ADDENDUM NO. 2

February 23, 2022

**DOUGLAS MACARTHUR ELEMENTARY SCHOOL ADDITIONS,
RENOVATIONS, AND RELATED WORK
Crown Point, IN 46307**

This Addendum consists of Pages ADD 2-1 through ADD 2-2 and attached Addendum No. 2 from Gibraltar Design dated February 21, 2022 and consisting of 7 pages, Specification Section 12 25 00 - Roller Shades and 52 drawings.

© GIBRALTAR DESIGN SHEET
G-104

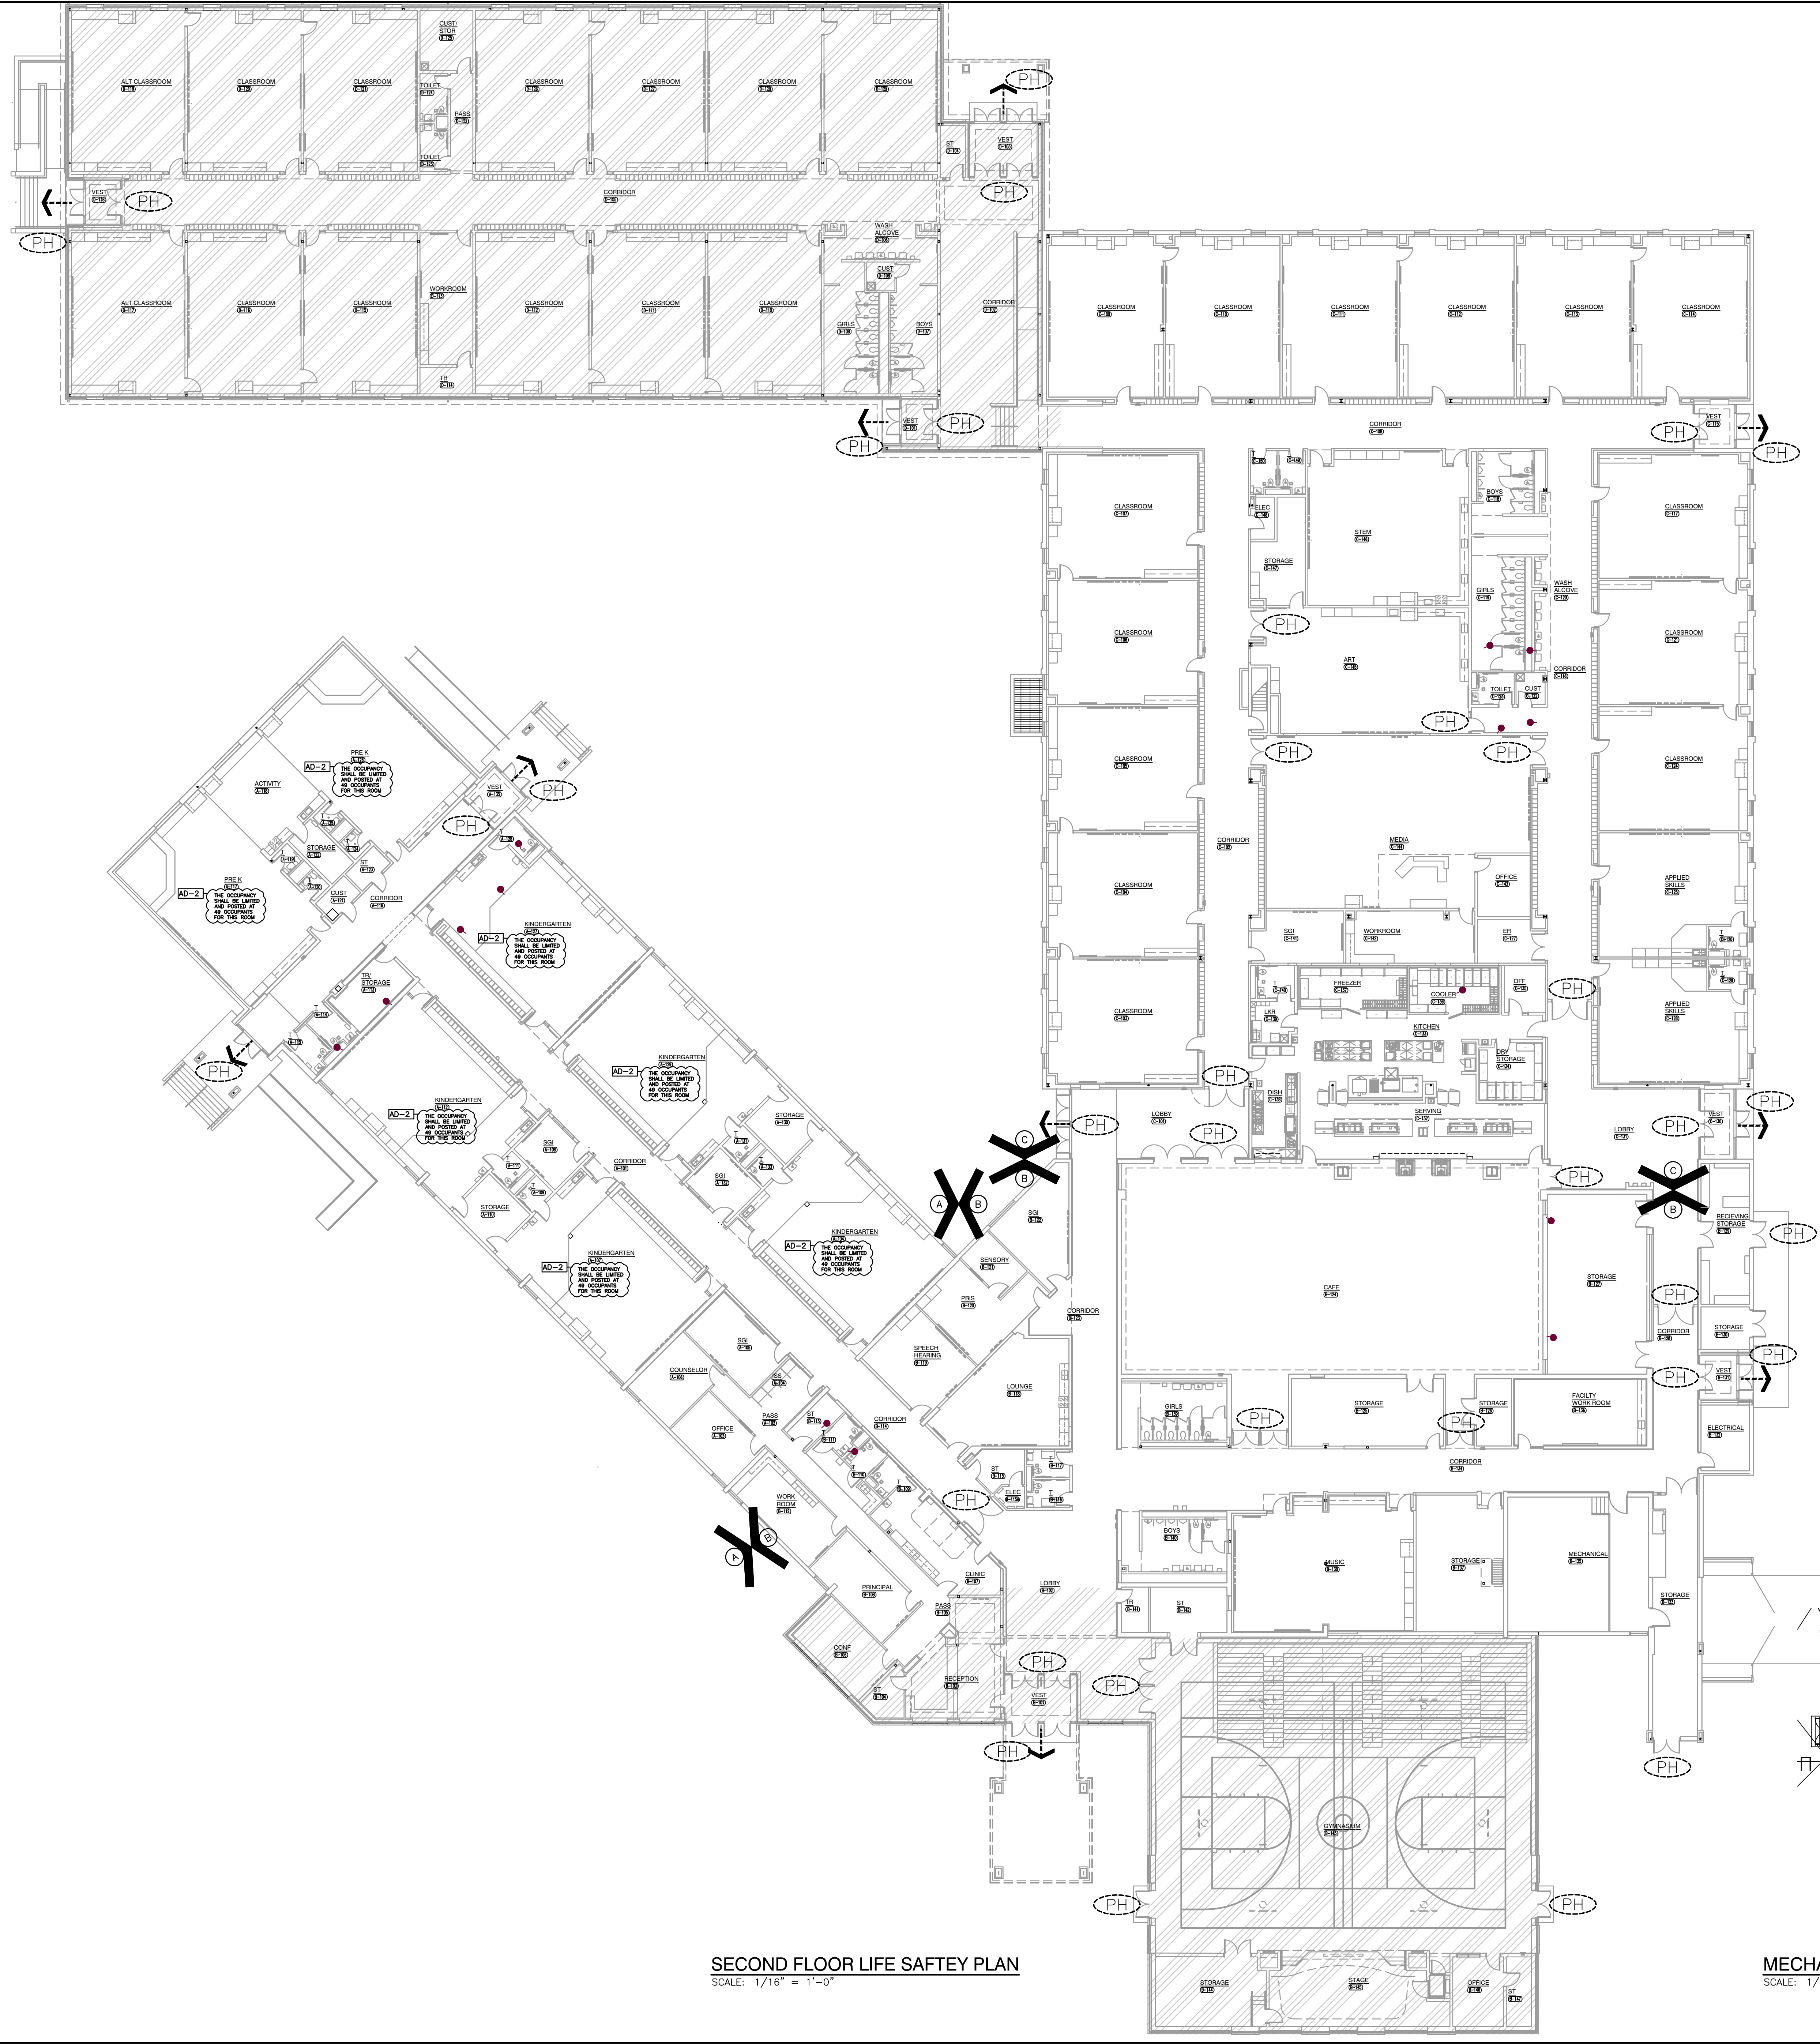
- A. Refer to revised, full size drawing, included in this Addendum, for the following revisions:
1. Add sheet A-412 Building Sections to Sheet Index.
 2. Revise Sheet S-202 sheet title in index.

A-408

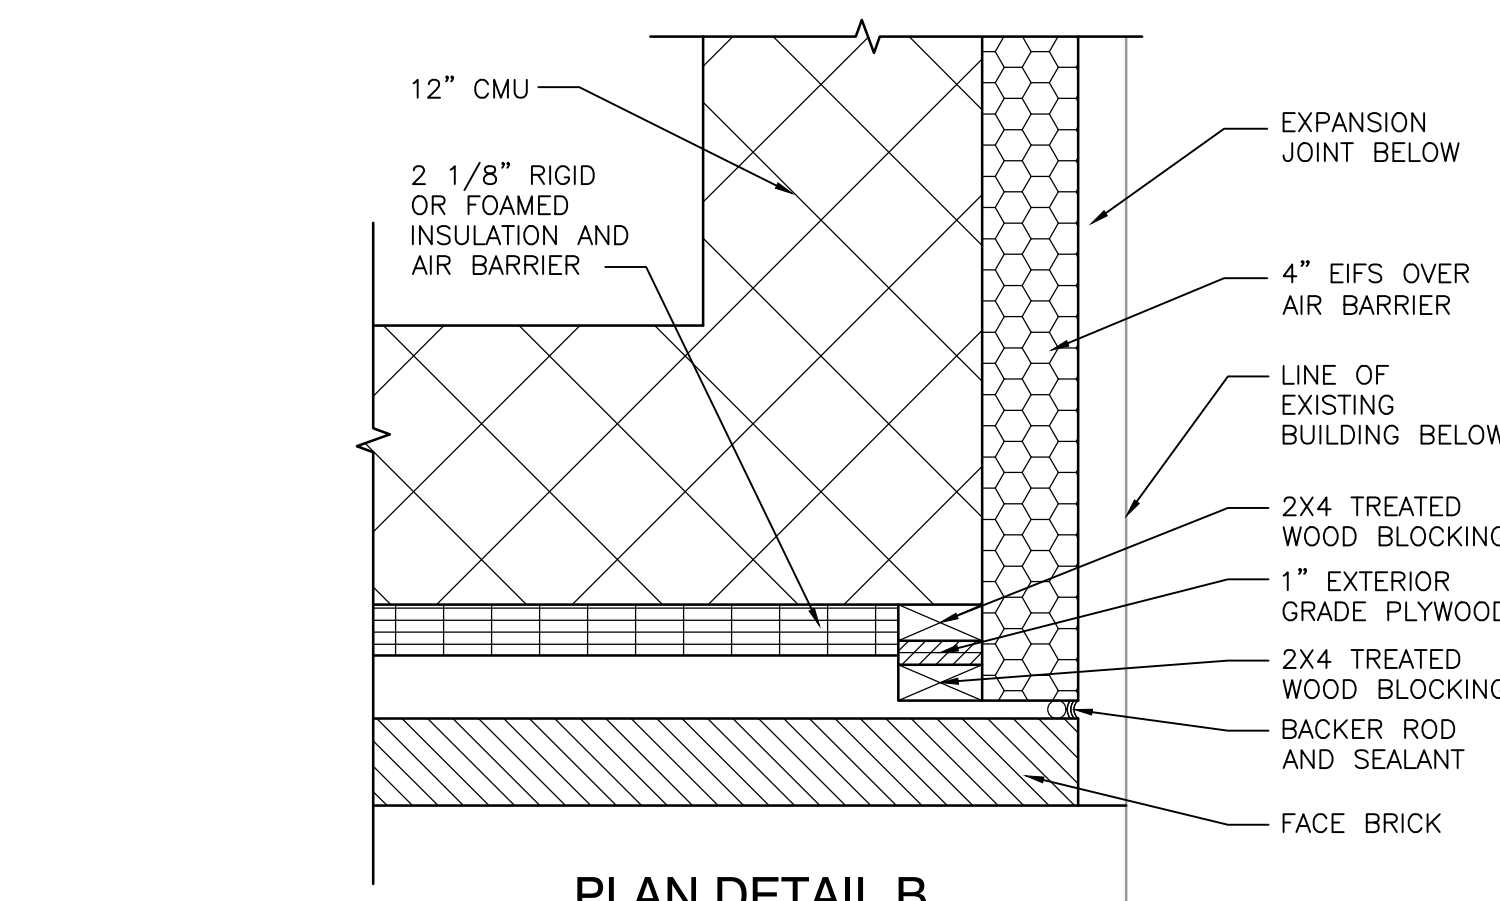
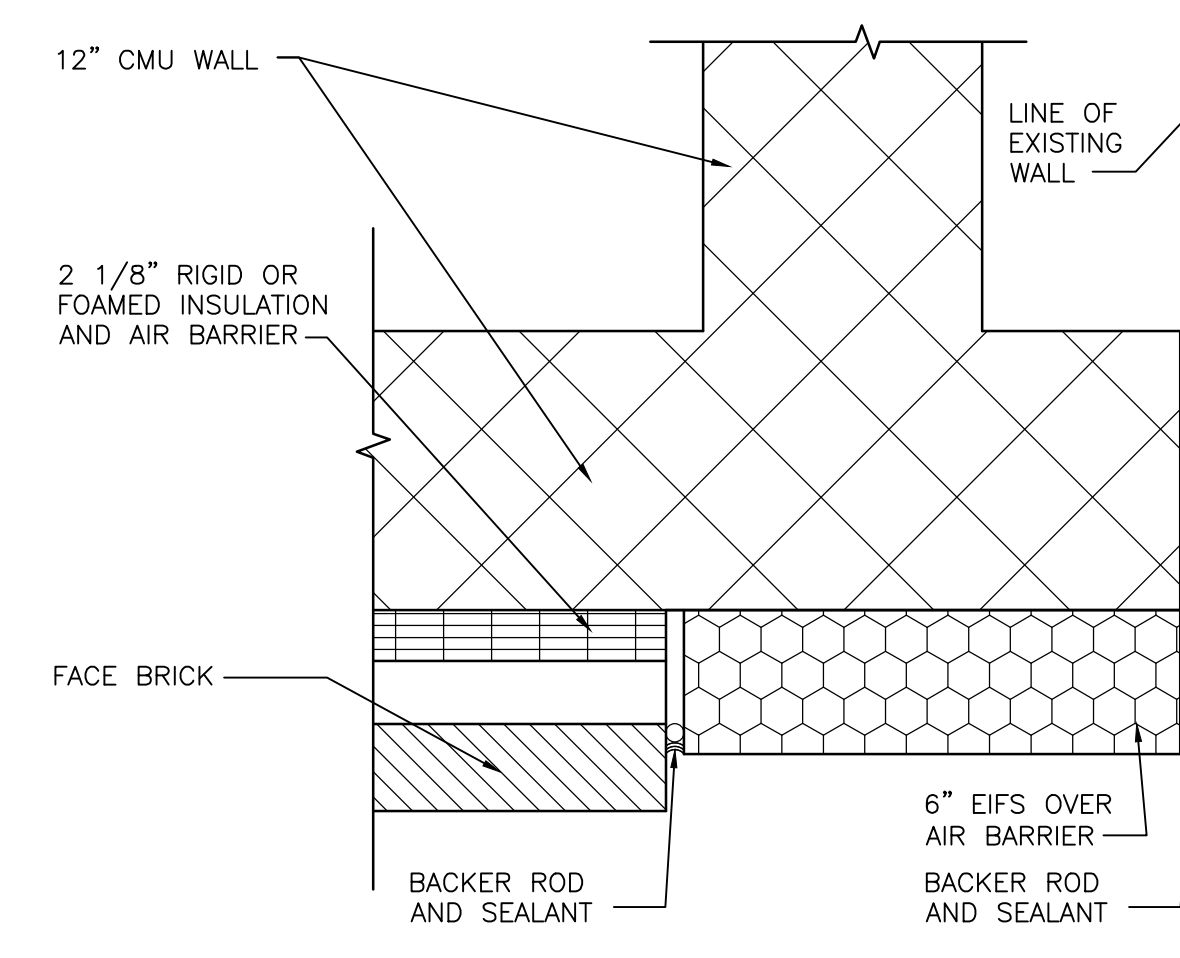
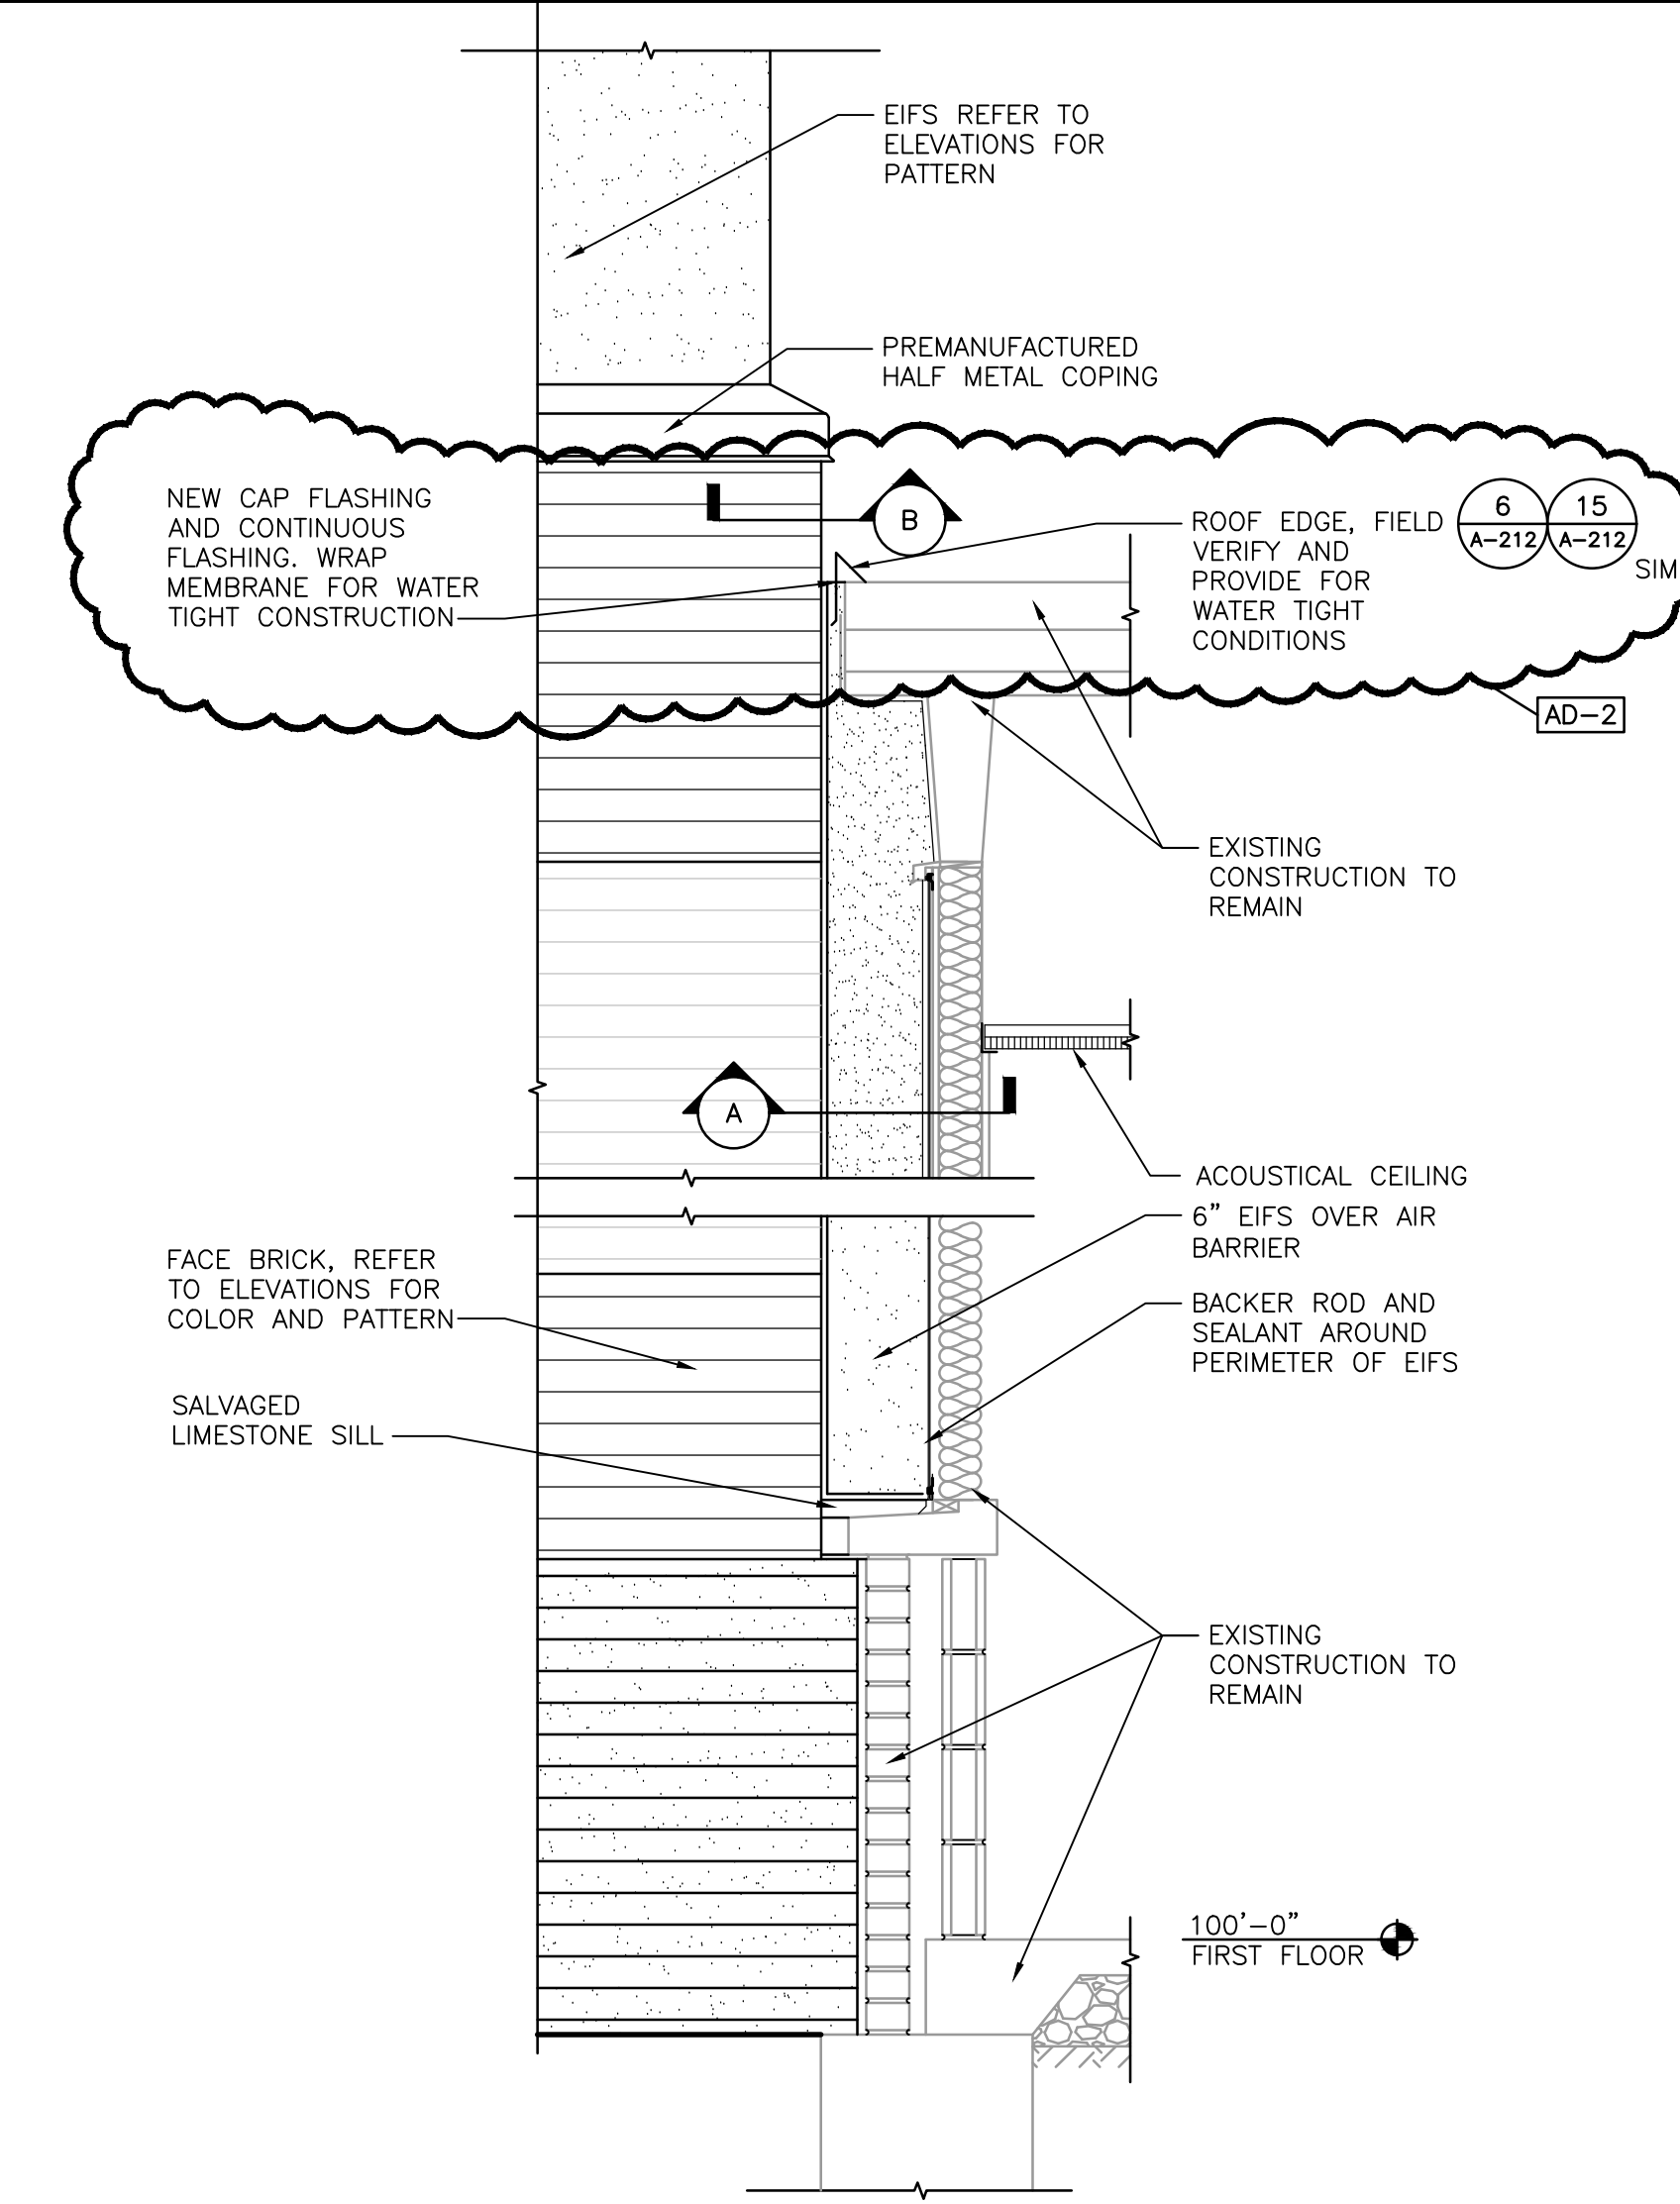
- A. Refer to revised, full size drawing, included in this Addendum, for the following revisions:
 - 1. Revise Reference bubble on 2/A-408
 - 2. Revise Wall section 4/A-408 with the two plan details to be 5/A-408 and update notes.
